## 1.0 Introduction

Conybeare Morrison International (CM<sup>+</sup>) was engaged by Inner West Council (IW Council) to conduct an independent peer review of the new Planning Proposal for 67-75 Lords Road, Leichhardt, dated August 2022 (the 2022 Planning Proposal). The review assesses the 2022 Planning Proposal against the key documents including Parramatta Road Corridor Implementation Plan 2016-2023, Parramatta Road Corridor Urban Transformation Strategy, Parramatta Road Corridor Urban Transformation Planning and Design Guidelines and the previous Lords Road Peer Review Report by CM<sup>+</sup> dated January 2019. The review focusses on the urban design aspects of the proposal and following key topics:

Figure 4 The Proposed Zoning Map (left) and the PRCUTS Recommended Land Use Map (right)

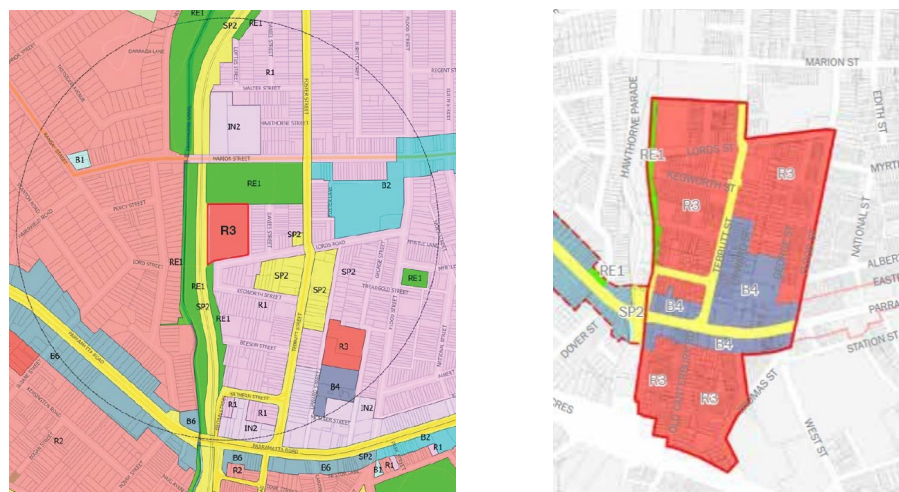
As noted above PRCUTS identifies a portion of the site as an RE1 Public Recreation zone along the Light Rail embankment. This is to provide a continuous public through link, through public space, along the eastern side of the Light Rail. The 2022 Planning Proposal includes a 6m setback along its western boundary allowing for a through site link, but does not identify any portion of the site as an RE1 zone. As the proponent seeks to rezone the site consistent with PRCUTS, it should demonstrate how the RE1 zone is incorporated into the scheme. The proposal does provide a public link along its western edge, it is not clear that this fulfills the intention of PRCUTS to secure a permanent public way at this location.

*It is recommended that the proponent clarify the intentions of future zoning configuration of the site and how the future RE1 zone is to be incorporated into the scheme.*

Figure 5 The Proposed Sections Showing the Proposed Height (Source: SJB)

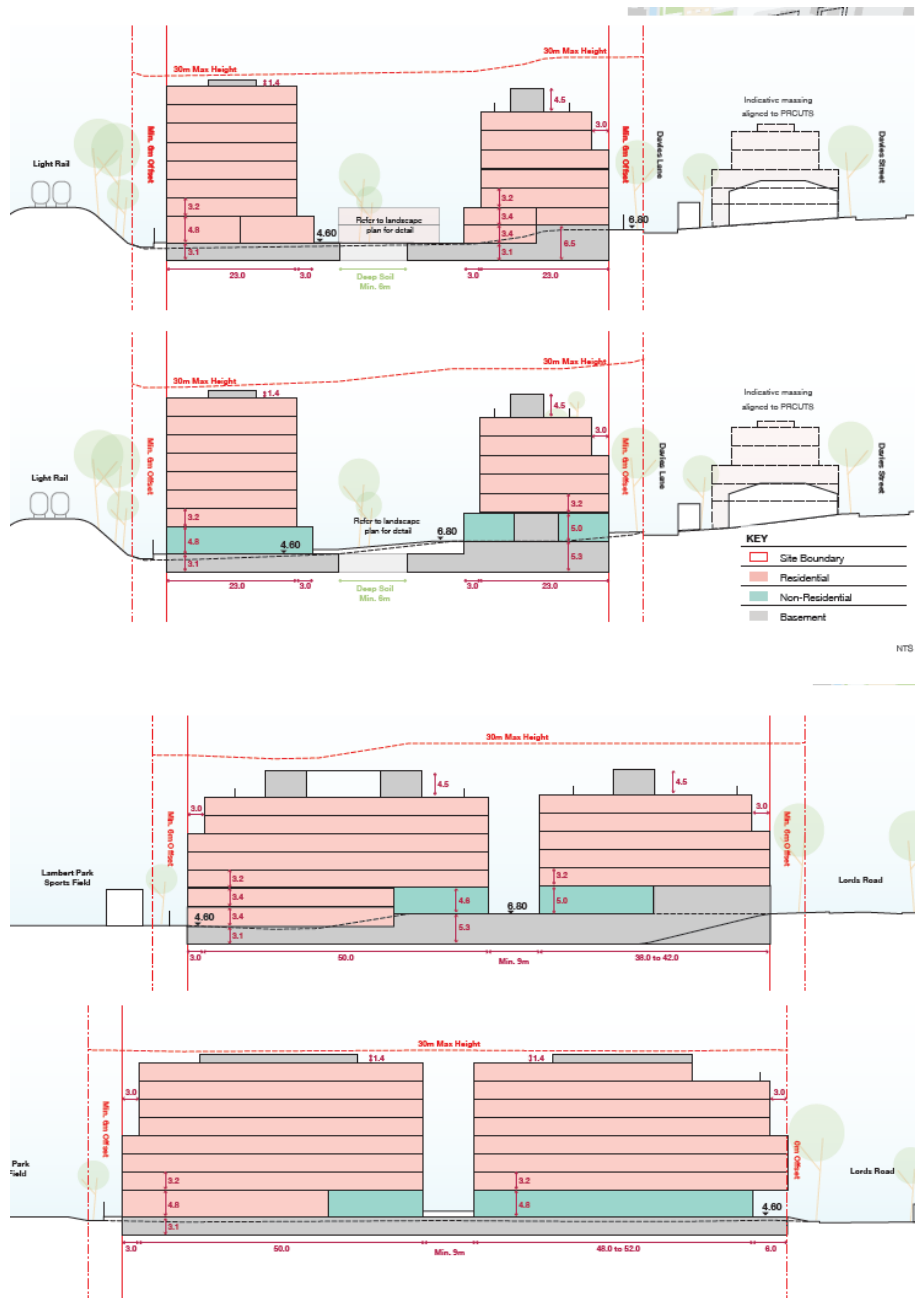
The proposed sections illustrate that all parts of the proposed buildings, including lift overruns are also within the 30m height limit. This height generally aligns with the existing tree canopies along the light rail which assists with screening the proposed tall buildings when viewed from the Heritage Conservation Area to the west and northwest.

Figure 7 The Proposal within the Potential Future Context (Source: SJB)

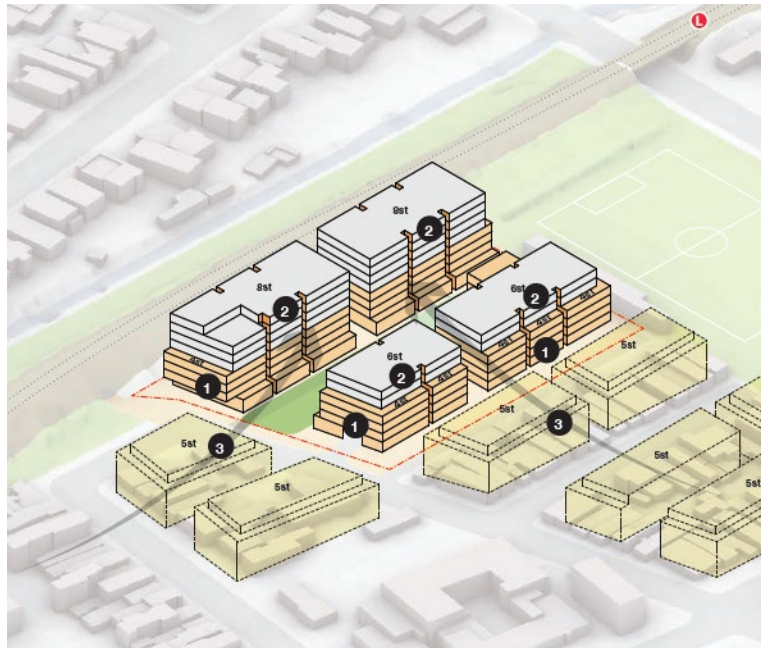
PRCUTS envisions five-storey buildings to the east of the site. The 2022 Planning Proposal’s four-storey streetwall height along Davies Lane therefore is compatible to the PRCUTS built form strategy. The proposed continuous 6m street setback and with additional upper level recessed from the four-storey streetwall further mitigate the bulk and scale along Davies Lane and is supported. However, the streetwall height facing the Light Rail embankment does not comply with the maximum of 18m (roughly 5 residential storeys) streetwall height recommended in the PRCUTS. The 8-storey built forms without secondary setbacks on the upper levels facing the western boundary do not comply.

Figure 8 Lords Road Section Showing the Proposed Setback Along Lords Road (Source: SJB)

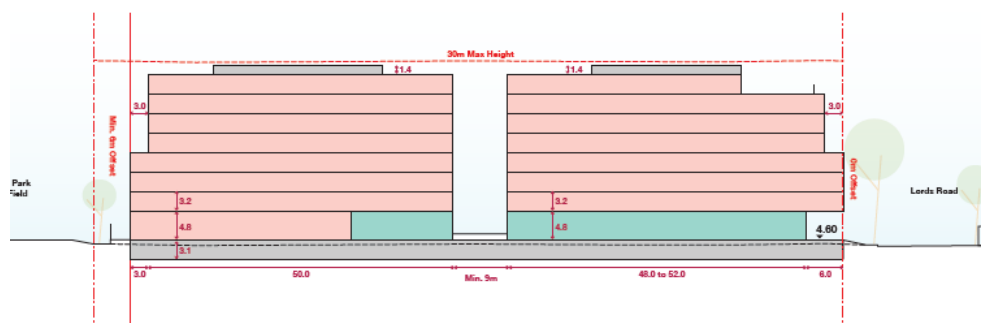
A 6m setback has partially been provided along Lords Road. This extends along the eastern half of this frontage and locates the façade of Building E. Building A, however, does not continue this setback. At the western edge of the site, at Building A, the setback becomes more critical as this area is adjacent to the Hawthorn Pedestrian Tunnel providing access to the GreenWay. Building A has 6m arcade at this location with upper level floors located over this zone. This arrangement eliminates the opportunity for tree planting at this location and will contribute to the building bulk when viewed from Kegworth Street.

*A continuous 6m street setback along Lords Road is recommended to provide a continuous streetscape, enable tree planting and potentially reduce visual impact. This setback should also be free from extrusions from any parts of the proposed buildings. The Proponent should also refer to PRCUTS streetwall recommendation.*

Figure 9 A Strong Pedestrian Circulation (Source of SJB)

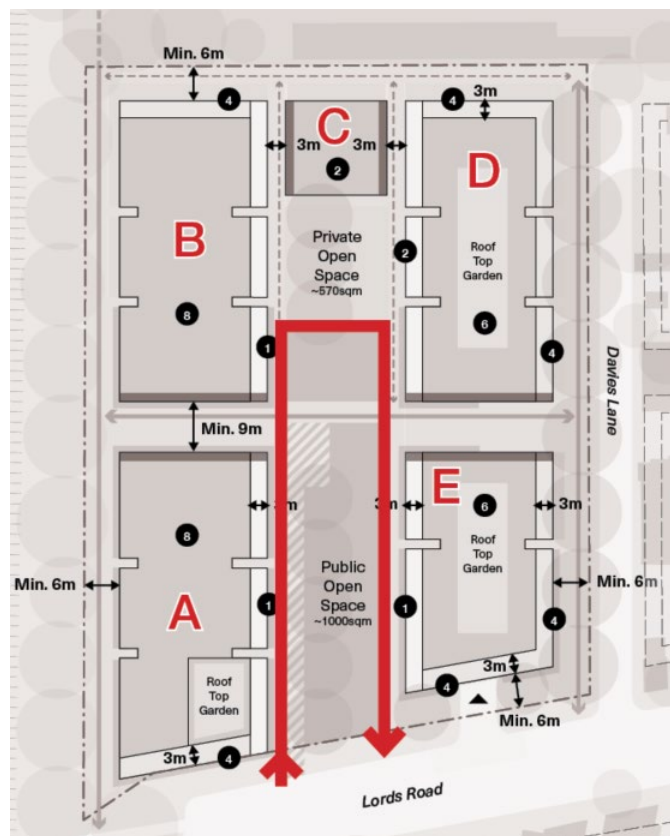
The proposed pedestrian circulation around the central open space is to be strengthened. A clear and legible pedestrian circulation, that links all the residential lobbies, is needed to improve the proposal's sense of address, in particular, for the buildings deep inside the block. The design in its current form presents a rather convoluted pedestrian access system, which is interfered with the shared path along Building A, parking etc.

Residential entries for Buildings A, B and D rely on the proposed façade indentations, which result in long and narrow corridors leading to recessed lift cores. This design outcome is not desired. More generous residential lobby areas need to be provided accommodating seating and gathering places. The Building E ground level reference scheme presents a better lobby design compared with the rest. This will also assist with wayfinding and contribute positively to the sense of address within the proposed development.

*It is recommended that the Draft DCP ensures that a legible and unencumbered pedestrian circulation 'street' connecting all the residential lobbies can be achieved in the DA stage. The Draft DCP should also promote generous residential lobby areas accommodating seating and incidental meeting opportunities and providing robust entrance identities.*

Figure 10 Public and Private Open Spaces (Source: SJB)

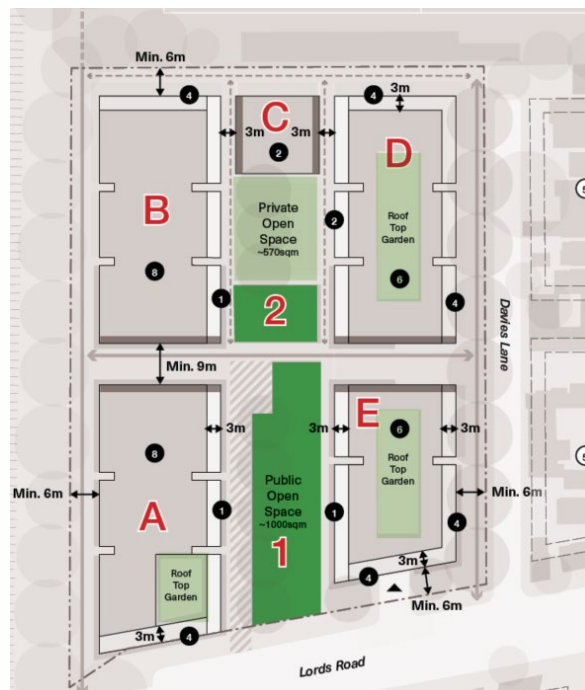
A 'Publicly Accessible Open Space' is proposed at the centre of the development; however it is divided by the proposed east-west pedestrian link. The northern part (No.2 in Figure 10) directly abuts the proposed ground level private communal open space. It is critical to separate public open space from private communal areas to ensure its adequate amenity and privacy. Both the landscape plan and the Draft DCP should provide adequate design provisions to ensure this can be achieved in the DA Stage.

Figure 11 East-West Link Landscape Plan (Courtesy of SJB)

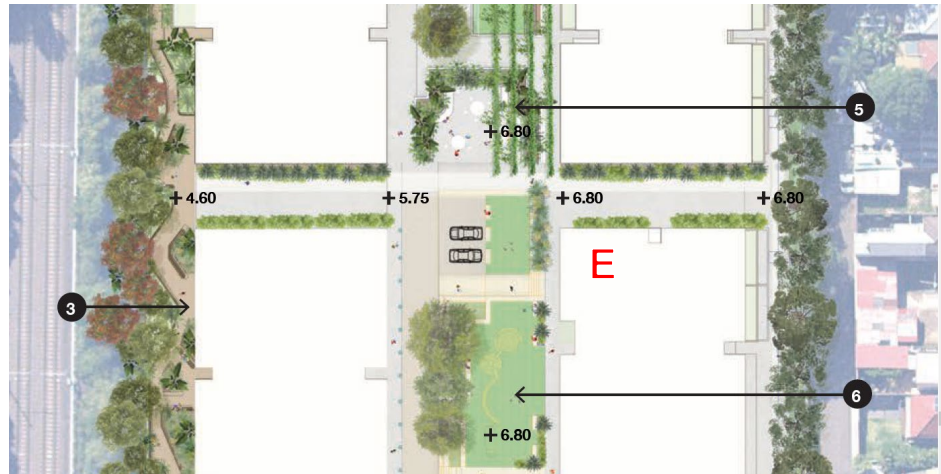
The place making strategy along this link, however, is unclear. This link is encumbered by the shared path, parking spaces, and a row of north-south trees close to Building E. The proposed DCP identifies active frontages along this link while the landscape plan illustrates a series of planters along the building façades. As illustrated, the design does not comply with the proposed DCP.

The proposed east-west through site link should have a more straightforward movement and activation strategy. It is also recommended that the Draft DCP to be further amended to ensure:

- public through site link along the western boundary will be delivered
- a clear separation between public and private open spaces is provided
- activation is provided to ensure CPTED outcomes are achieved

Figure 12 The Draft DCP Figure 3 Showing the Proposed Building A Setback to Lords Road (Source: SJB)

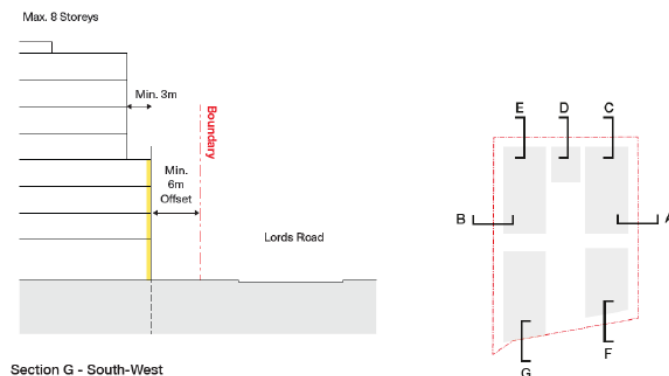
- The Draft DCP Figure 3 (see below) has a min. of 6m setback control for Building A, whereas the Urban Design Report section does not indicate this. The Draft DCP control, providing a continuous 6m setback along Lords Road to enable street tree planting etc., is supported.

Figure 13 Lords Road Footpath Widening (Courtesy of the Department of Planning and Environment)

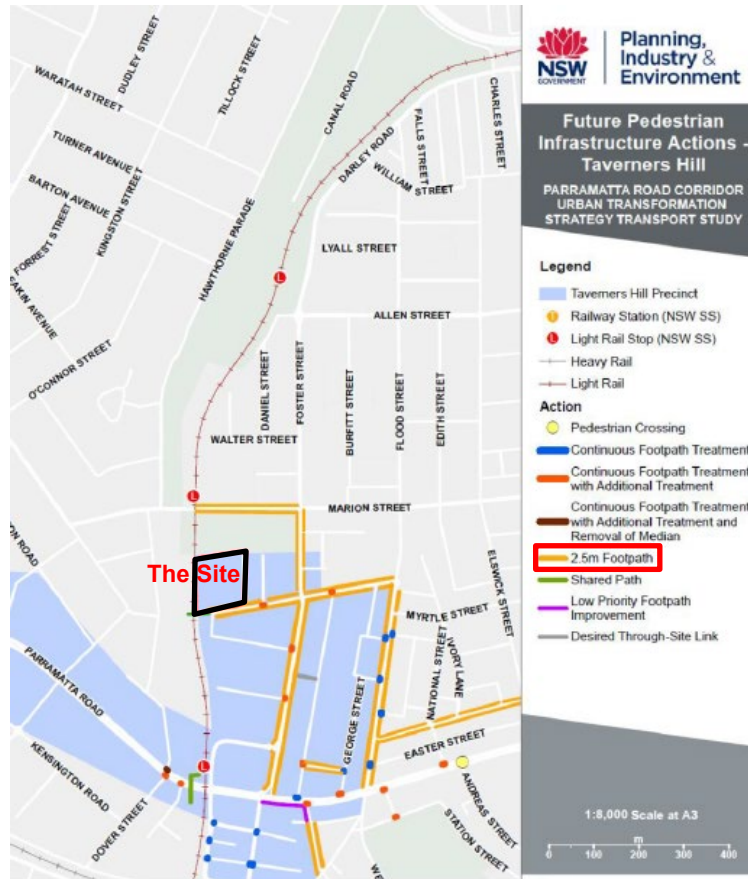
- The Davies Lane sections are not detailed enough to understand the proposed streetscape and the functions within the proposed 6m setback. Considering the basement extrusion along Davies Lane and tree removals etc., detailed street sections need to be provided.
- Lords Road footpath widening is identified by the Department of Planning and Environment and Inner West Council commissioned Cardno to undertake the Parramatta Road Corridor Precinct Wide Traffic and Transport Study. The Transport Plan identifies a 2.5m wide

footpath to Lords Road. The proposal's relationship with Lords Road footpath widening is to be demonstrated.
